From: Scala, Mary Joy
Sent: Wednesday, September 23, 2015 4:37 PM
To: Powe, Gregory; Woodard, Keith
Subject: BAR Action – September 15, 2015 – 200 2nd Street SW

Certificate of Appropriateness Application

BAR 15-09-07
200 2nd Street SW
Tax Parcel 280069000, 280071000-280075000
Powe Studio Architects, Applicant/Market Plaza LLC, Owner
Refinements to building and plaza and landscape design

**CITY OF CHARLOTTESVILLE
BOARD OF ARCHITECTURAL REVIEW
STAFF REPORT
September 21, 2015**

4B

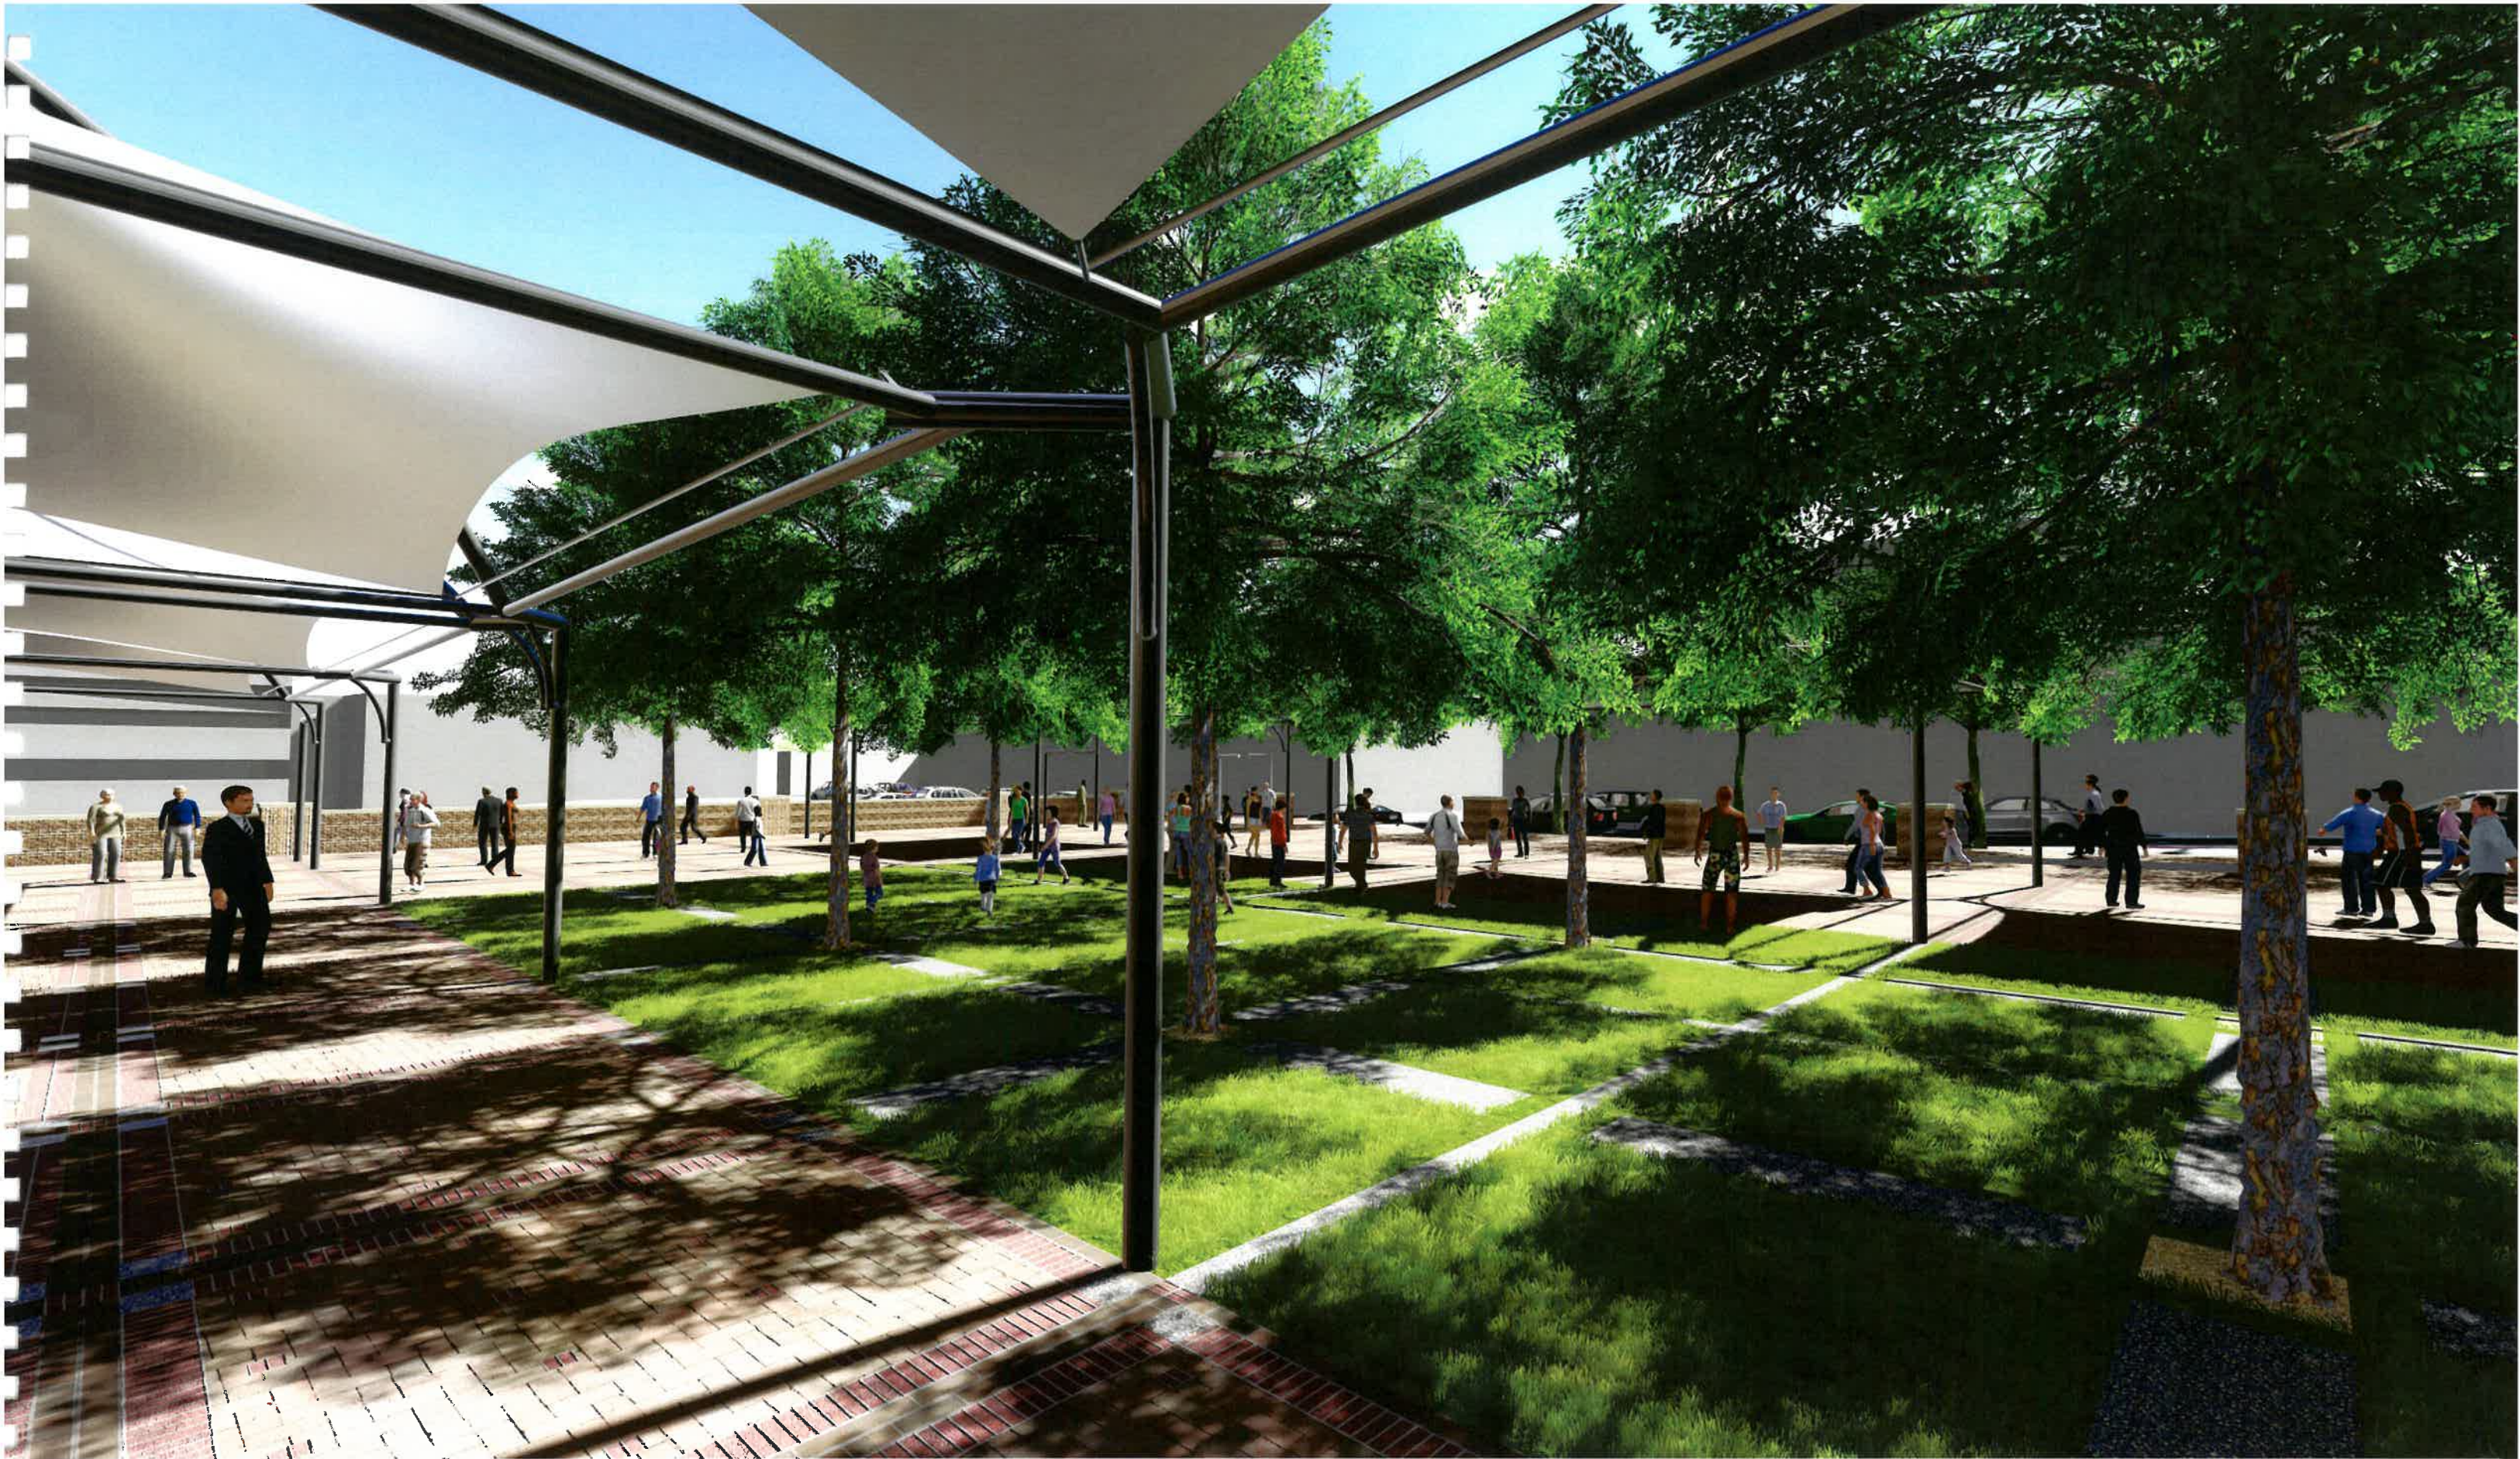
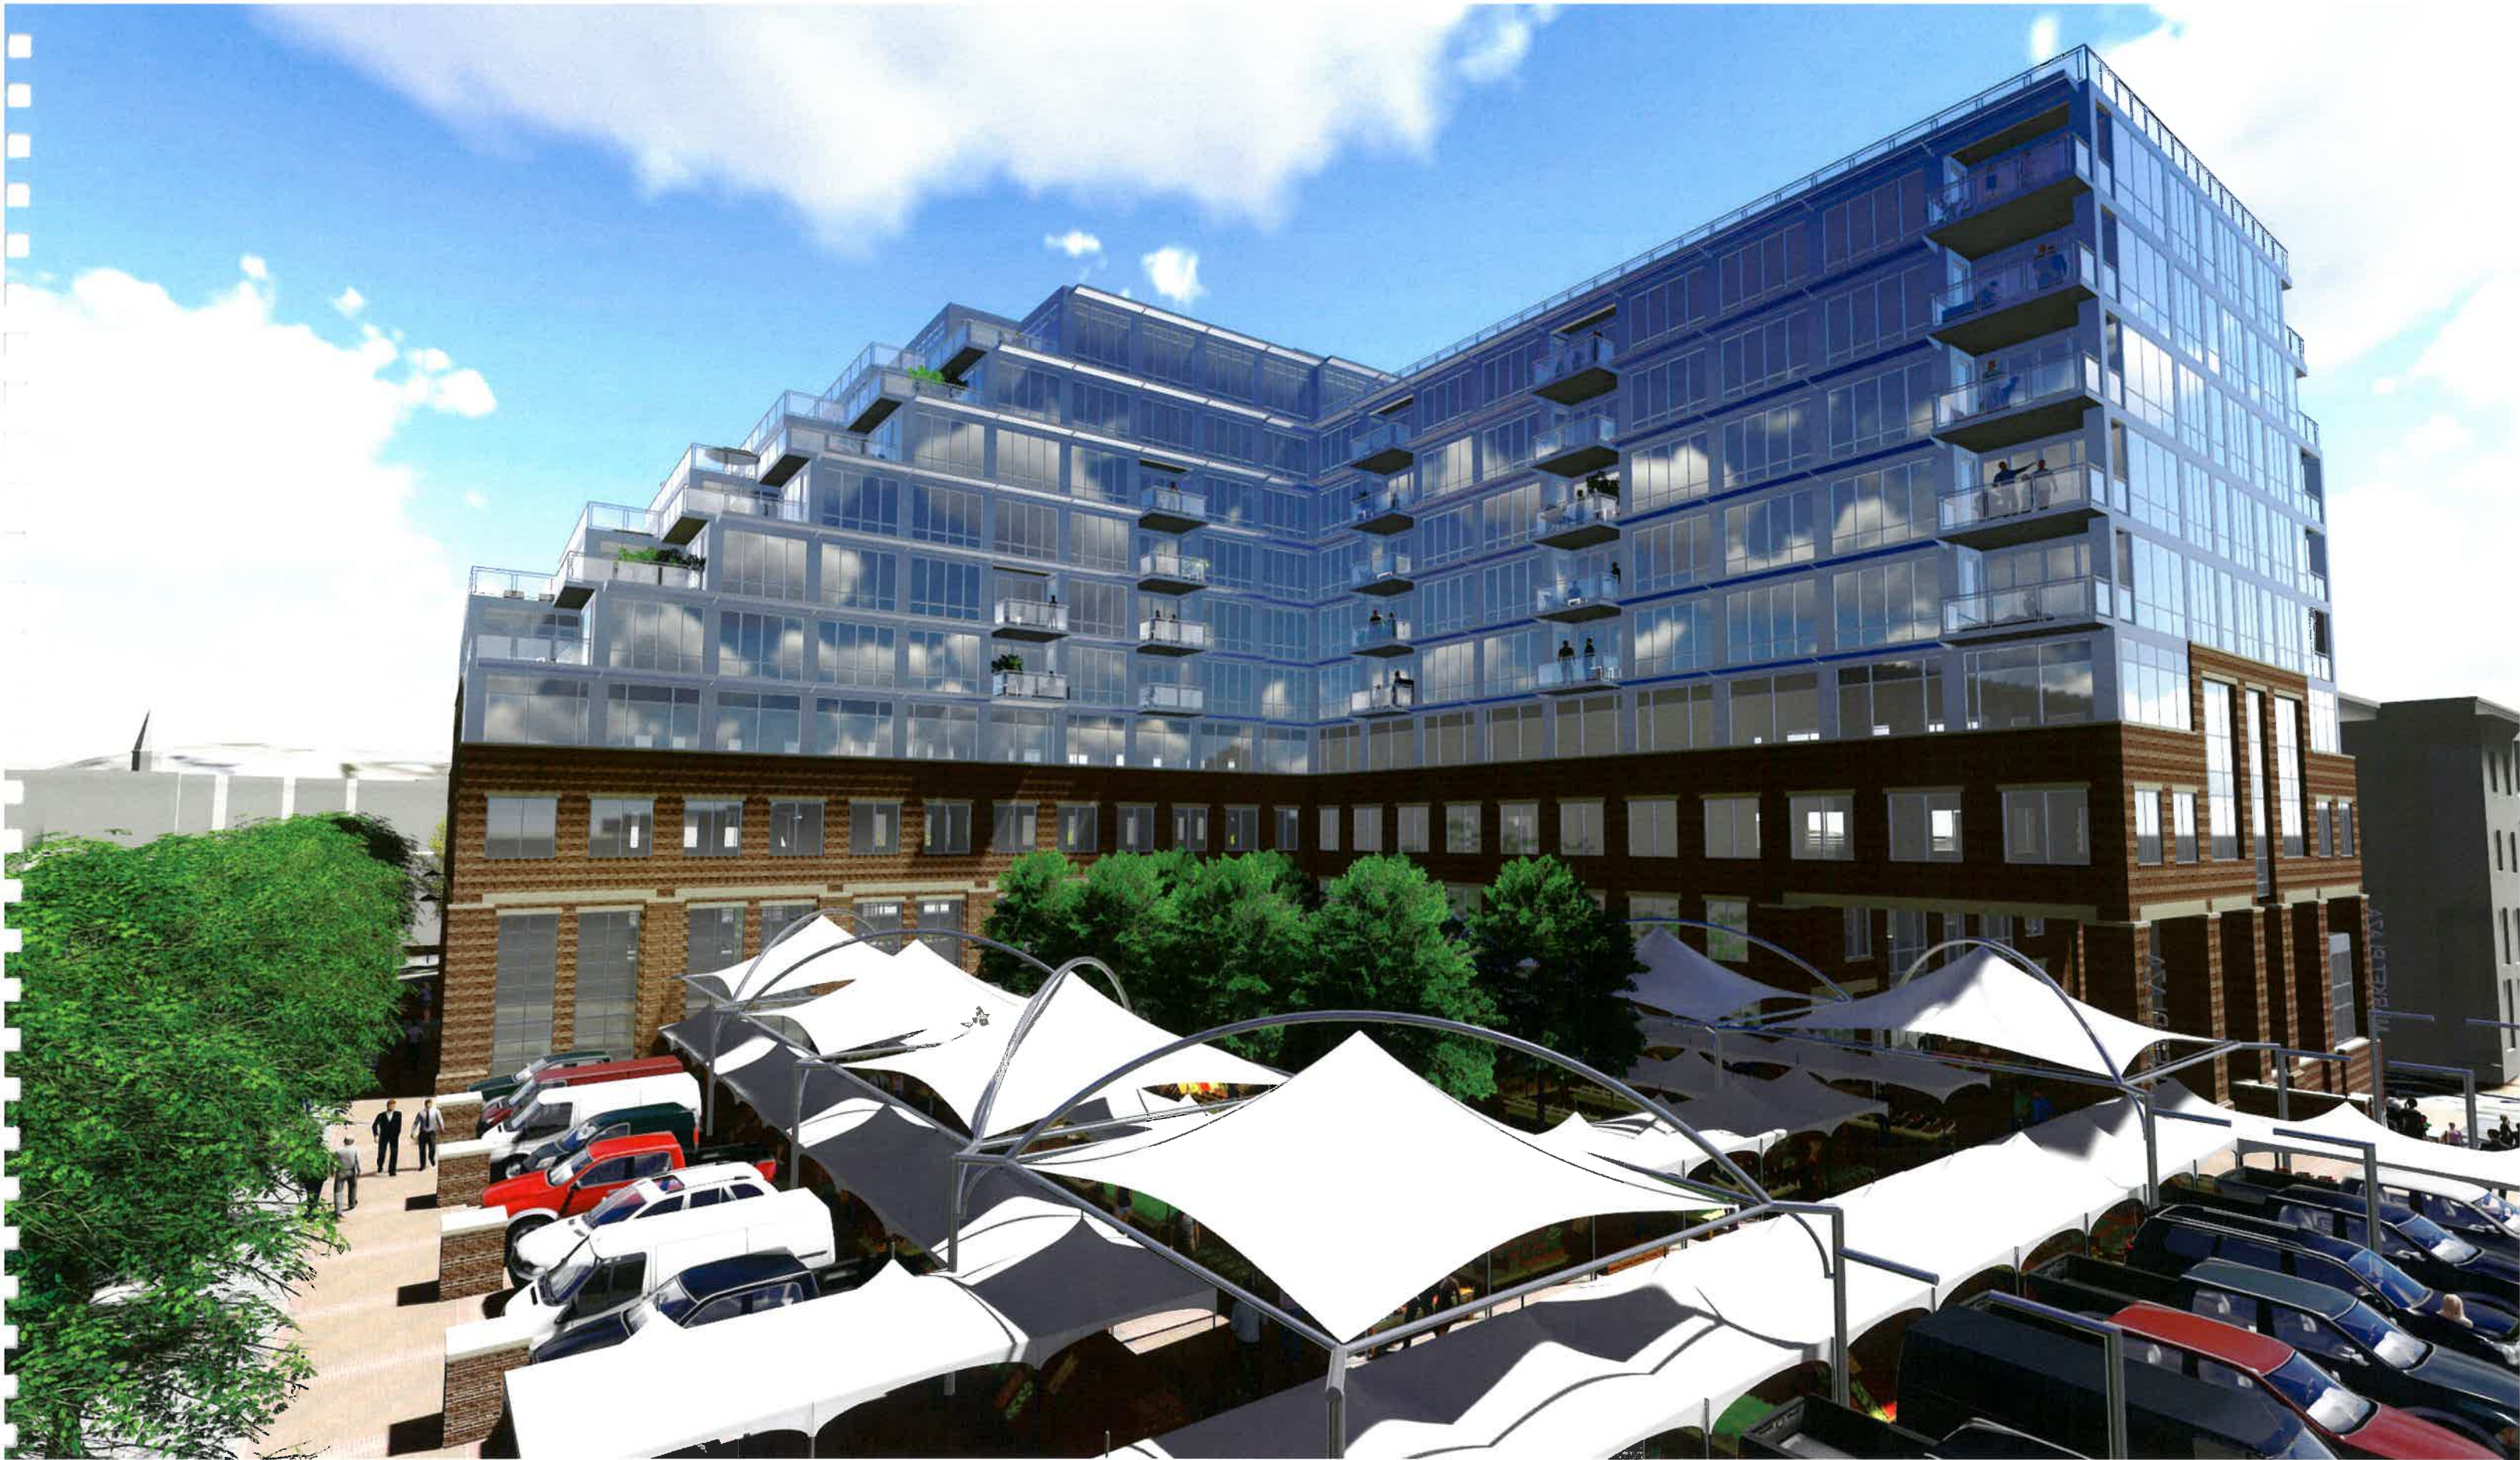
- Will the lawn area appear as depicted on Sheets 3A-4B, or divided up as shown on Sheets 8 and 10?
- Better depictions are needed for the new stair landing on South Street; the new stair that replaces the retaining wall on South Street; and the new stair to the parking garage located on the plaza near 1st Street.
- A cut sheet or more details for the fold up doors at events space.

The BAR approved the application as submitted (7-1-1 with Keesecker opposed and Schwarz recused) with the exception of: adding a planter wall next to the grand stair between old 1st Street and the parking lot; change to granite banding in the tree lawn will be 8" and 24" to align with plaza brickwork; and back to the original brick base design on the building.
